## Product Change Notice (PCN)

**PCN Number:** PCN-0374437R-01

Product(s) Affected: *CS-3603, CS-3606, CS-3612 & CS-3624*

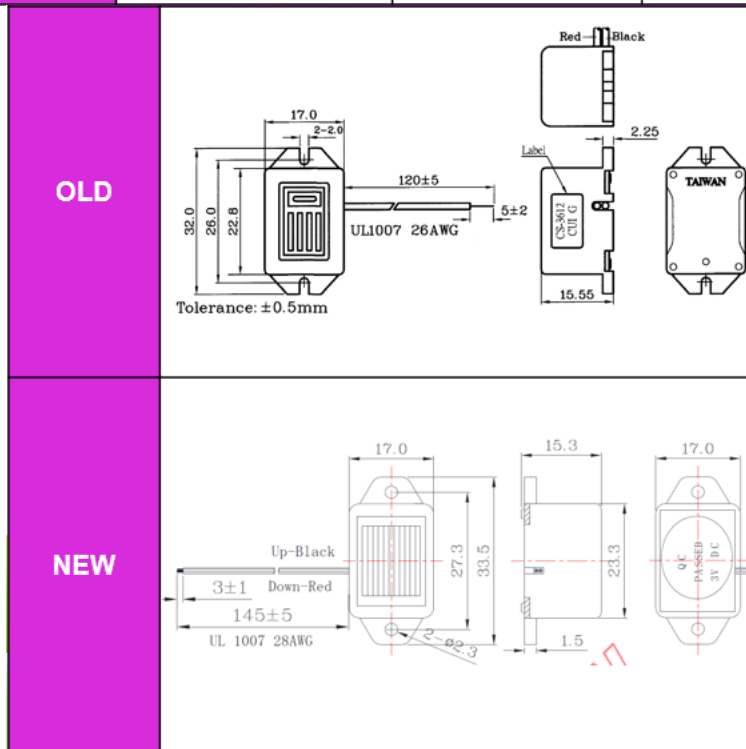
Description of Change: *Current consumption has decreased by 10mA on CS-3603 & CS-3606, it has increased by 5mA on CS-3612 & increased by 11mA on CS-3624. Operating voltage on CS-3624 has a new minimum of 18VDC. SPL has been increased by 3dB on CS-3603, CS-3606 & CS-3612. SPL has been increased by 2dB on CS-3624. Operating temperature on all four models has been widened to -30~70°C. Storage temperature on all four models has been shifted to -35~75°C. Some dimensional changes & elongated sound holes (shown in drawing below).*
